ADDENDUM TO BUSHFIRE THREAT ASSESSMENT REPORT DATED 10TH NOVEMBER 2011

PORT MACQUARIE HOSPITAL POD 4 AND 5 ADDITION

Reference: **11186a**

Subject Property: **Port Macquarie Base Hospital
Lot 23 DP 1099567 Wrights Road
Port Macquarie NSW**

Figure 1 – First Floor (Ground Level) floor plan identifying fire and smoke compartmentation and external required exits.

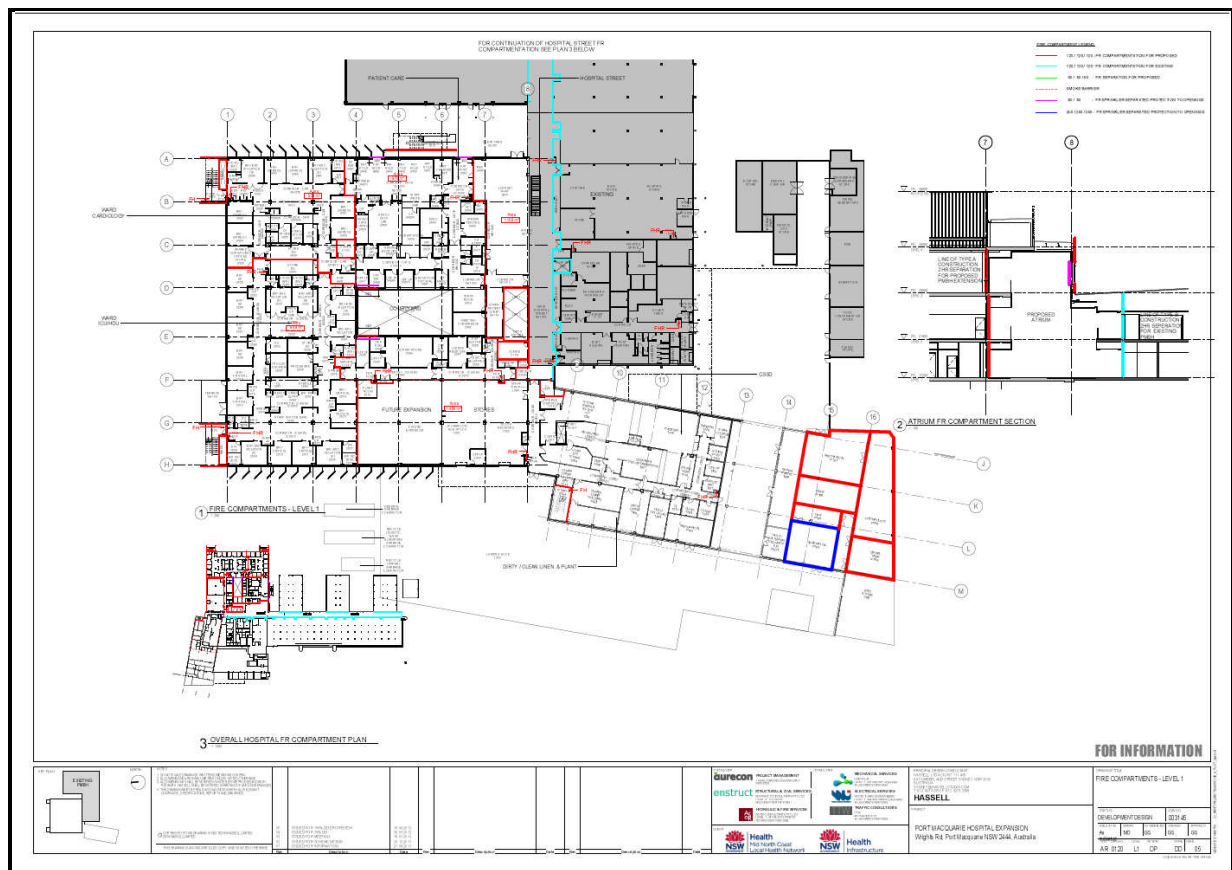
In addition to the external required exits there are a number of fire and smoke compartments (see Figures 1 – 3) within the building that will allow for horizontal evacuation which is generally the preferred means of escaping the effects of fire in a hospital development. The building is required by the Building Code of Australia to have an automatic shutdown of the air-conditioning system which will limit the spread of smoke externally with the building and fire

As shown in the following Figures 1 - 4 the building has many external required exits that will be shielded from the hazard and or greater than 60m from the hazard to the west allowing emergency personnel to assist people without significant exposure to the hazard i.e. $<10\text{kW/m}^2$. It is noted that there are many more external required exits to the east and south of the proposed development and within the existing building that area greater than 60m from the hazard and allow occupants to evacuate externally.

These passive and active measures within the building required by Part E of the Building Code of Australia will provide significant measures in addressing the objective of s4.2.3 PBP2006 to limit the impact of occupants from the effect of smoke and heat when evacuating the building, it being noted that horizontal evacuation is the first option in hospital evacuation to limit exposure of occupants to external elements.
